**RE: 2 DELMAR PARADE, DEE WHY – S4.55 APPLICATION  
RESPONSE TO COUNCIL COMMENTS**

As requested, please find herein The Transport Planning Partnership's (TPPP) response to the traffic related comments made by Northern Beaches Council (Council) for the above proposed development.

TITLE: B99 VEHICLE SWEEP PATH GROUND LEVEL

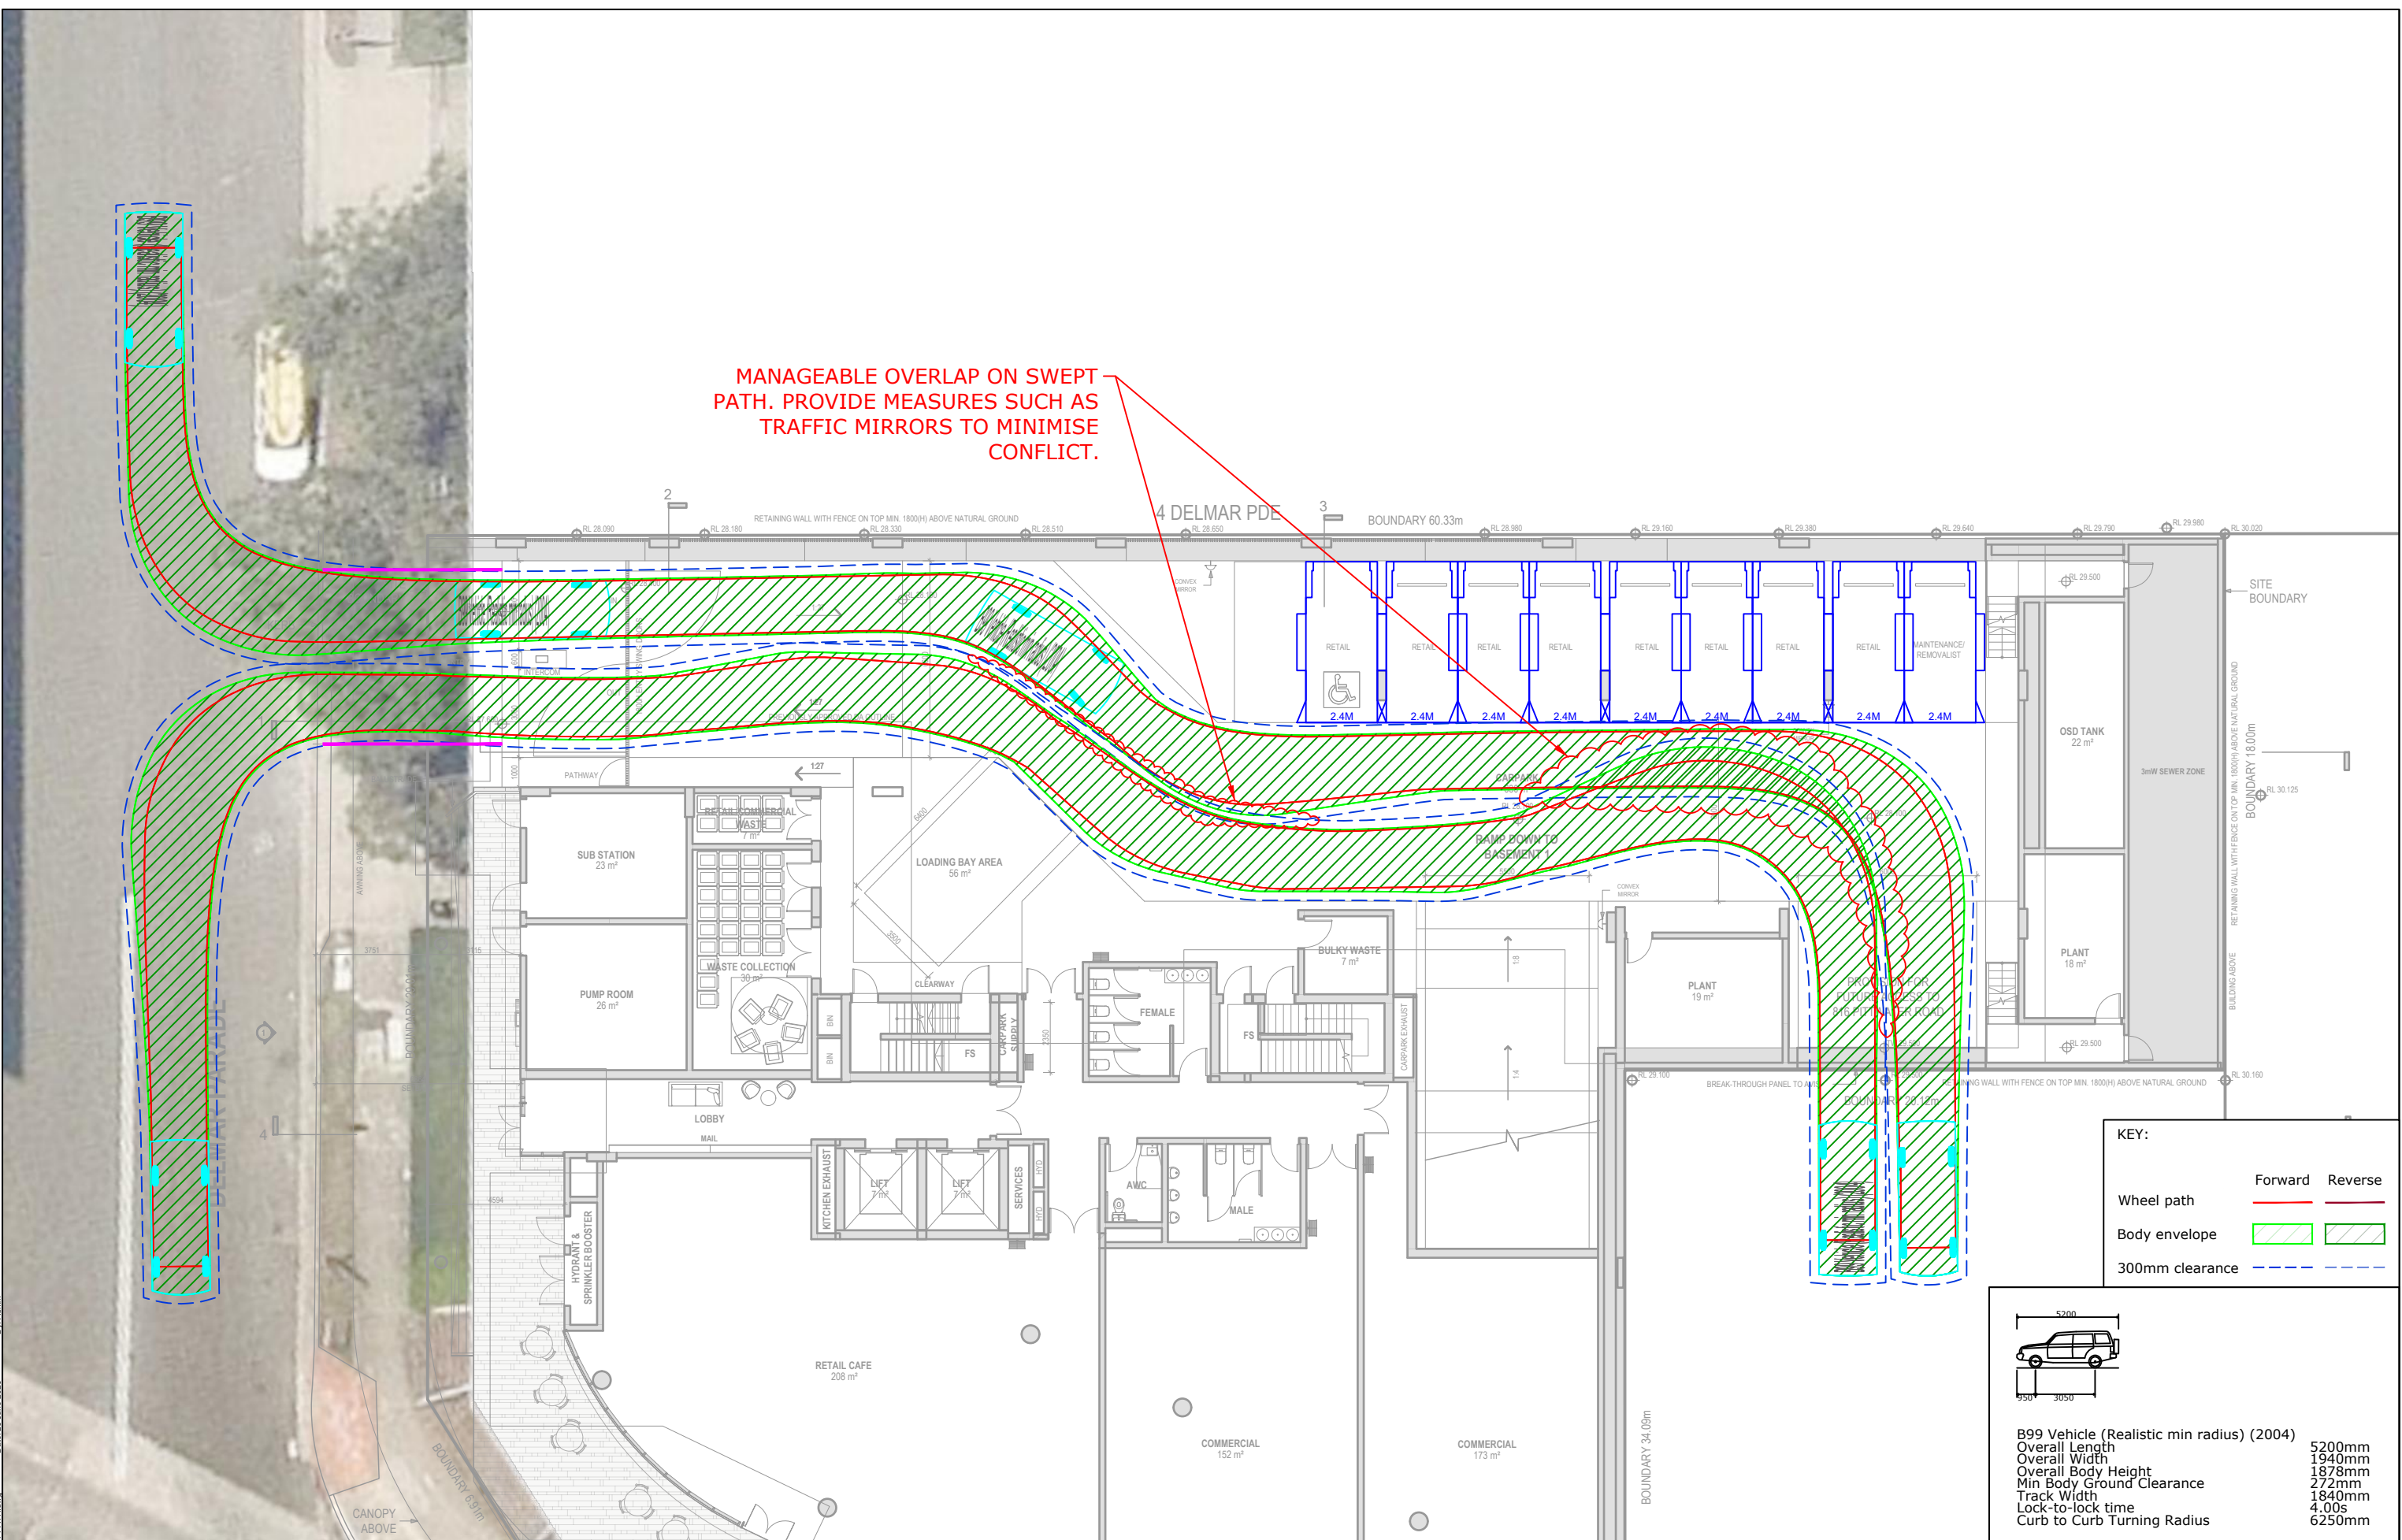
The swept paths in Attachment Three indicate that there is conflict with two-way flows between B99 vehicles at bends and intersections. However, we note that it is not uncommon for car parks designed to Australian Standards, to have conflicts at bends and corners, with the theoretical swept paths being generally conservative.

Nonetheless, it is considered that two-way flows at these conflict points should be managed with the provision of appropriate traffic management measures, such as convex mirrors to improve sight distance at the following locations:

- between the site access and the loading bay
- between the basement one ramp and loading bay
- between the aisle and access into 814-816 Pittwater Road.

MANAGEABLE OVERLAP ON SWEEP PATH. PROVIDE MEASURES SUCH AS TRAFFIC MIRRORS TO MINIMISE CONFLICT.
